UNION TOWNSHIP BOARD OF TRUSTEES  
DECEMBER 12<sup>TH</sup>, 2023 MEETING

## OVERLAY DISTRICT PLAN

CHARLES FRANCUS, Applicant  
1136 OLD STATE ROUTE 74

### *Staff Report: CASE # 13-23-O*

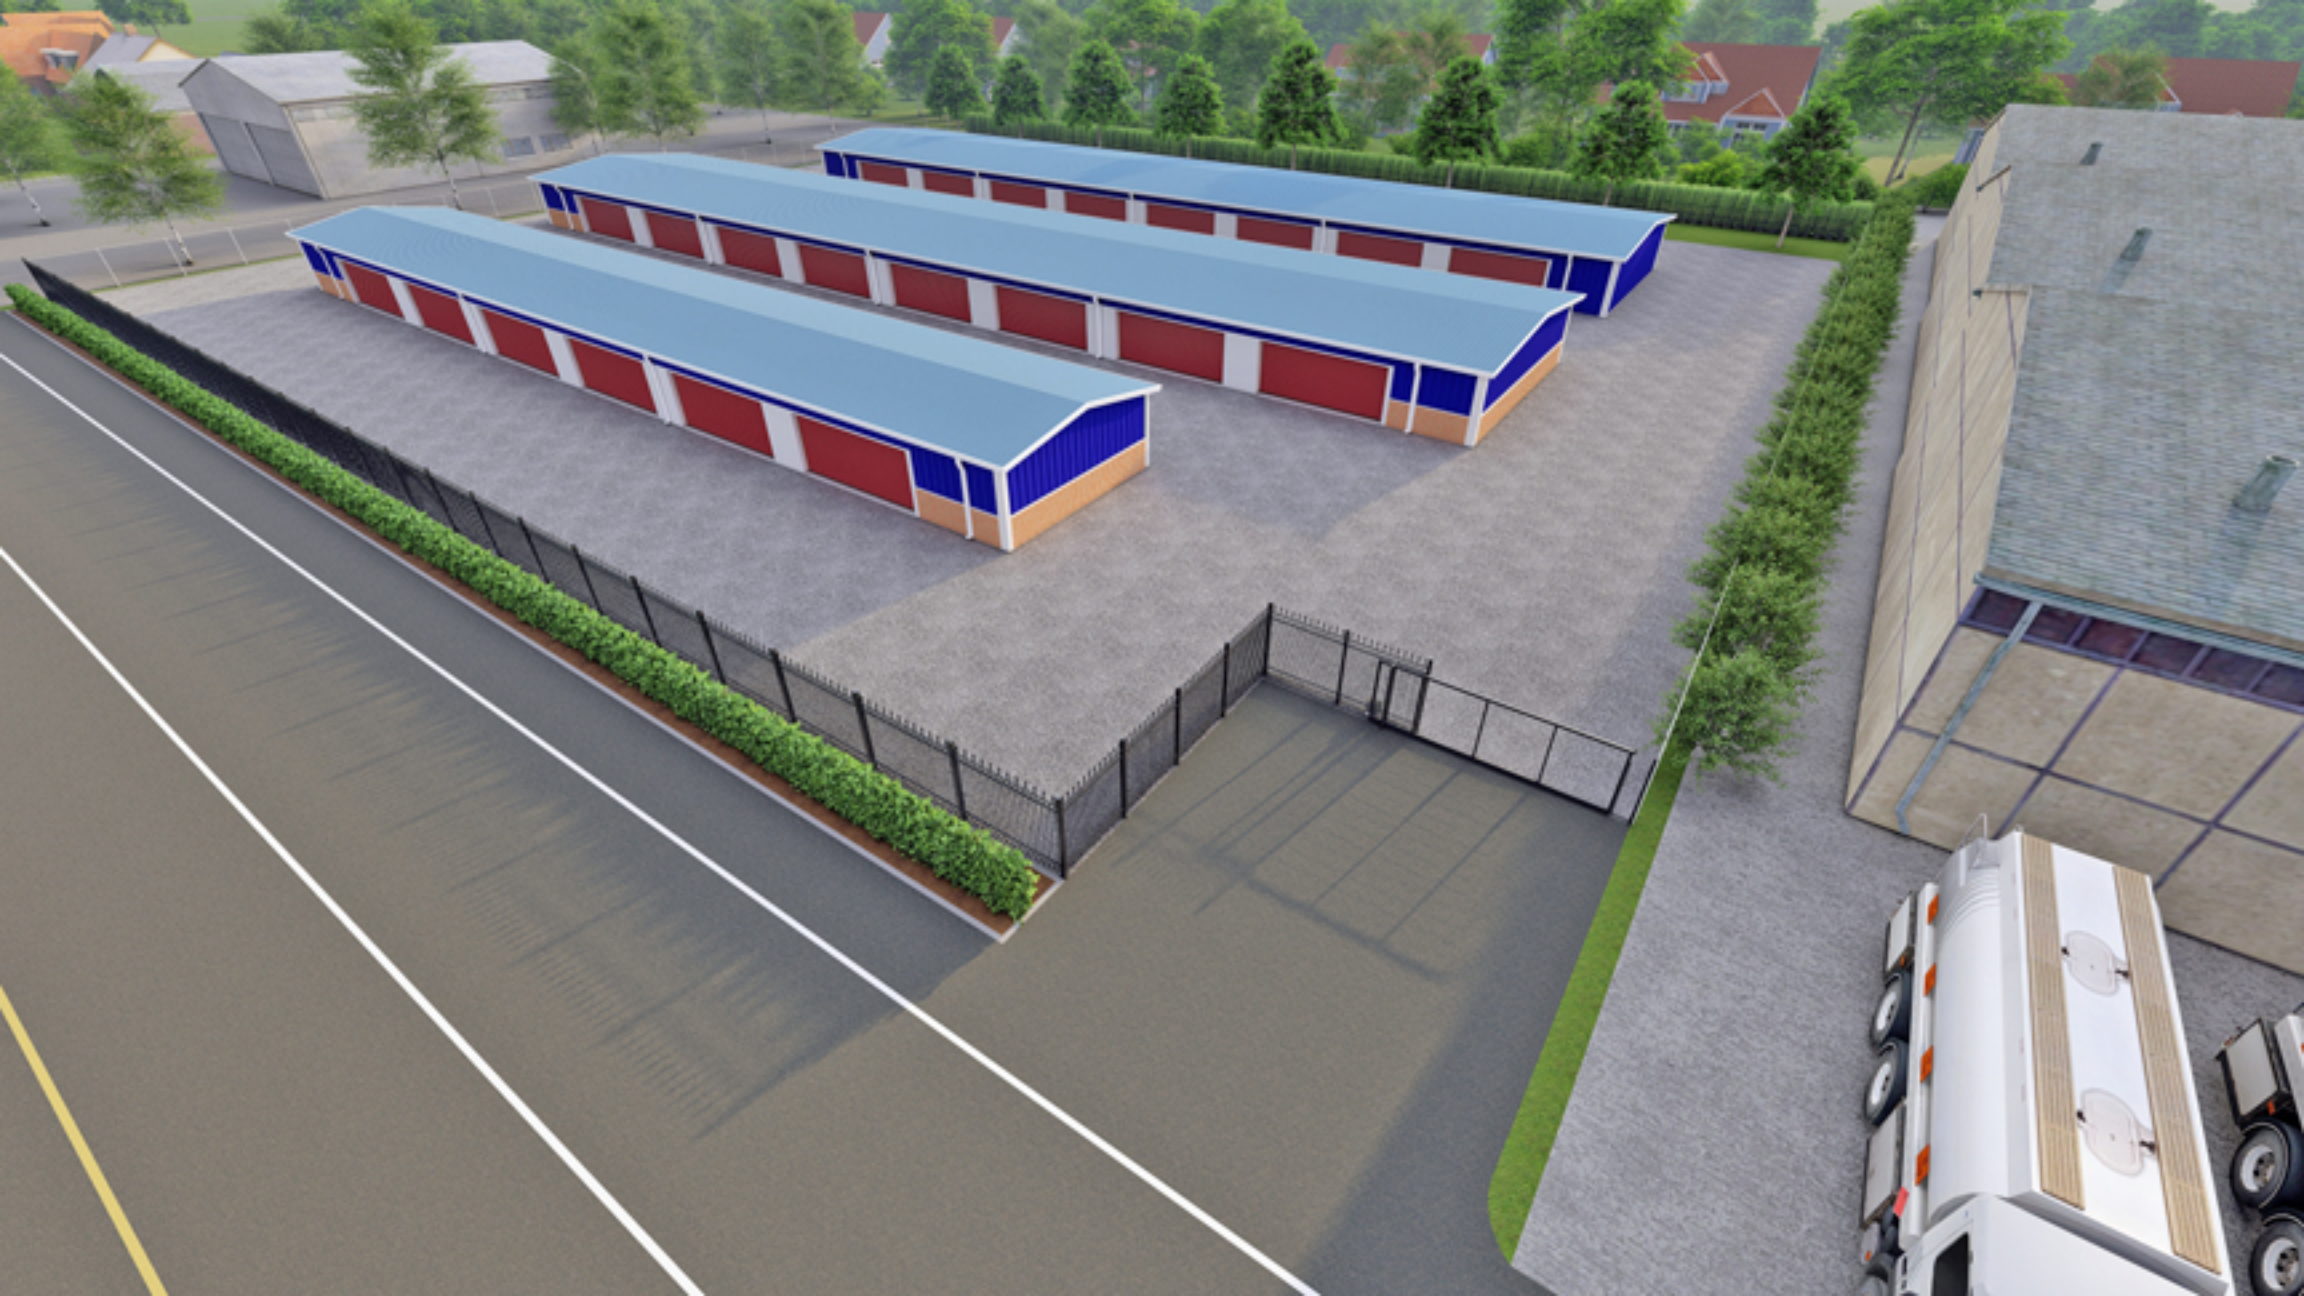
A review of the ‘preferred’ conceptual site plan indicates that there are three (3) single-story, self-drive-up storage unit buildings proposed for this property. The current application shows three (3) proposed structures being: 30 feet x 160 feet (rear), 30 feet x 180 feet (middle), and 20 feet x 140 feet (front). In total, the Applicant is requesting 13,000 square feet of storage building space on the lot. *The majority of surface proposed on the site is gravel—which would require relief.* However, the Applicant has shown a paved entrance area into the site, in an attempt to restrict gravel from leaving the property. As the current plan shows, front yard setback relief would be needed, with the proposed front structure being located approximately 27 feet away from the front property line—*instead of the required 40-foot front yard setback.* Although the property to the rear of this site is zoned Business (B-1), it is being used for multi-family residential purposes. Therefore, rear yard setback relief would also be needed as the proposed rear building is shown on the current plan as being located approximately 35 feet away from the rear property line—*instead of the required 100-foot front yard setback.* Currently, there is no specific information regarding the proposed building materials, to ensure that at least half of visible building faces from Old State Route 74 meet or exceed the Township’s requirements regarding the use of high-quality, traditional building materials (as set forth in the Zoning Resolution and Comprehensive Plan for this particular Corridor). There has not been a signage package submitted and although some details have been provided with respect to proposed landscaping along the front and rear of the site, a formal landscaping / buffer yard plan has not been submitted. Finally, there has been no lighting plan submitted; however, the Applicant has noted that the proposed facility will feature solar lighting.

- 2) The Applicant would need to provide a more detailed landscaping plan—including more information regarding the types of the proposed plantings, and details regarding proposed fencing. Additionally, all *existing* landscaping to remain and proposed landscaping should be marked as preservation area(s), and any vegetation disturbed should be repaired, supplemented, or replaced. *This is an item that can be addressed administratively by staff.*

- 4) A photometric / site lighting plan would ultimately need to be submitted. All lighting would also need to be noted as being downward directed, and of sufficient intensity to illuminate without projecting onto the adjoining property. \*Details / specs of proposed lighting would be necessary. *This is an item that could be addressed administratively by staff.*

- 6) Unless relief is given, at least fifty-percent (50%) of the proposed building materials visible from Old State Route 74 need to be traditional building materials or high-quality building materials, as defined in the Zoning Resolution, and to demonstrate consistency with the Focus Overlay District Area and the Comprehensive Plan. To date, no information has been submitted to acknowledge the intended building materials. *This is an item that could be addressed administratively by staff.*

# **OUTDOOR VEHICLE STORAGE VARIATION**

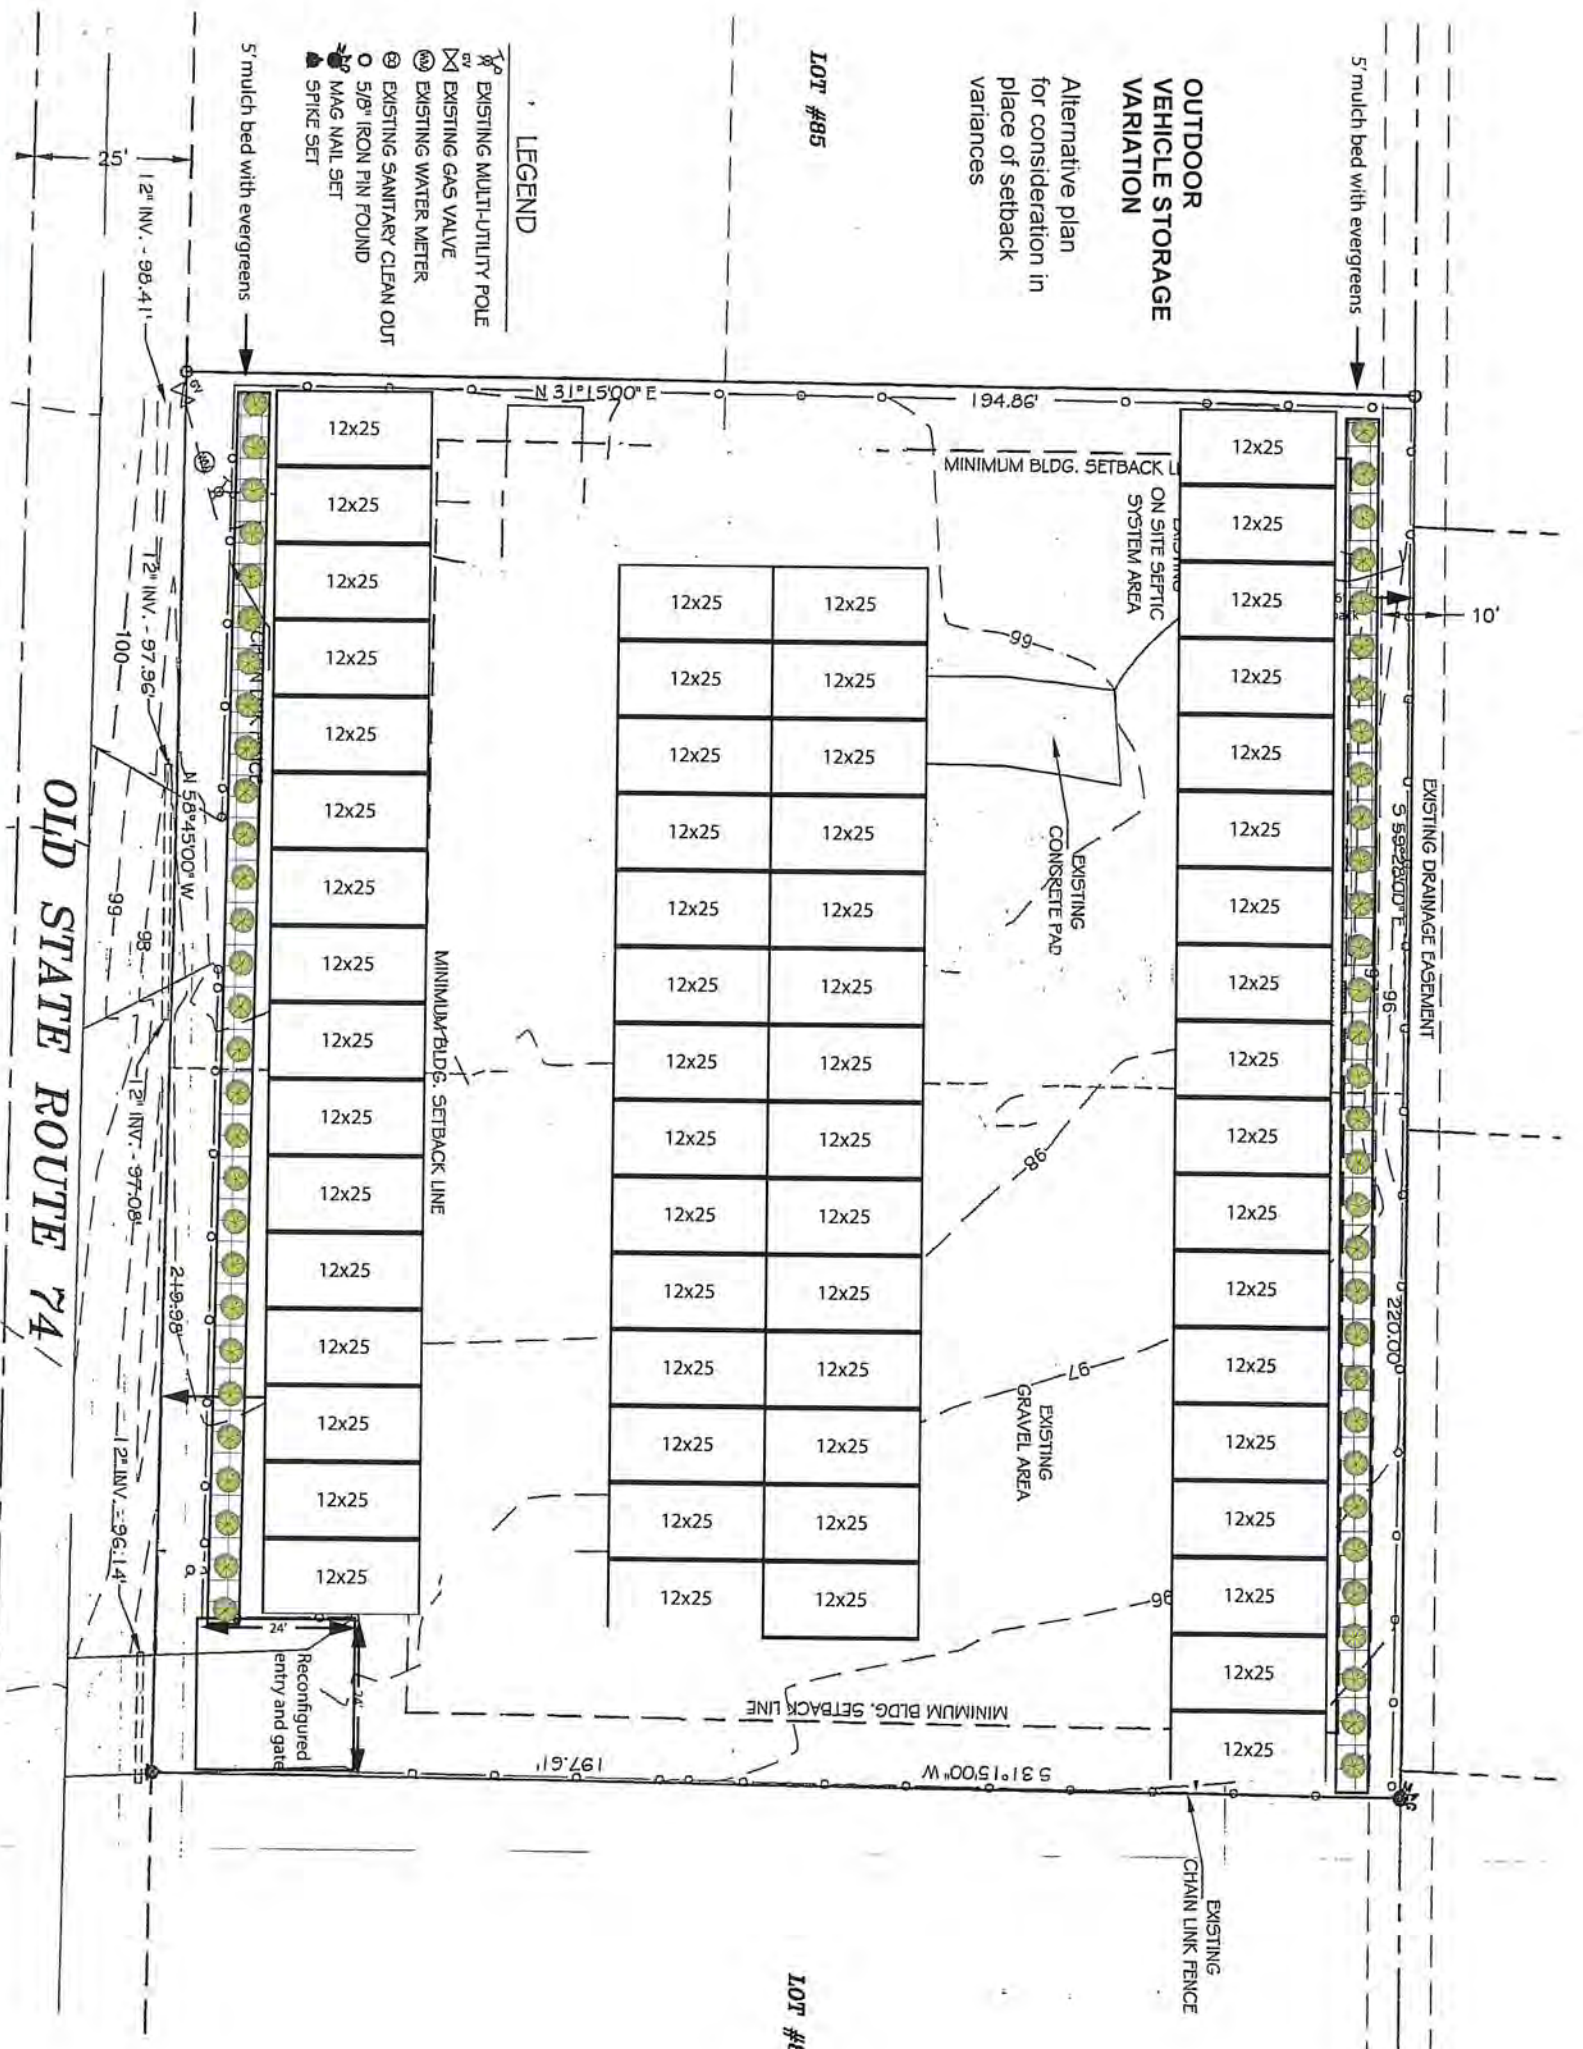
Additionally, the Applicant has submitted an ‘alternative’ conceptual site plan to request an increased intensity to the pre-existing, non-conforming outside storage use on the property—if the ‘preferred’ conceptual site plan with the three (3) storage buildings is deemed unacceptable. Although the building material and building setback issues would potentially be removed for consideration of such an ‘alternative’ plan, there would be additional compliance issues and / or concerns with respect to the Union Township Zoning Resolution: Article 5, Section 532 (Parking and Storage of Vehicles and Trailers); Section 716 (Long-Term Parking Facilities as Accessory Uses); Article 8, Section 801 (Off-Street Parking Design Standards); and conceivably Article 8, Section 805 (Parking of Disabled Vehicles). Furthermore, Article 6, Section 661 of the Zoning Resolution recognizes that parking and storage—of automobile, motorcycle, truck, trailer, farm implements, etc.—may be allowed in Business (B-1) districts under certain circumstances, if such storage is situated in a completely enclosed building or facility. Outdoor vehicle storage areas are not recognized directly in the text, so Section 664 has been typically reserved / referenced for uses not specifically / otherwise identified in the ordinance text.
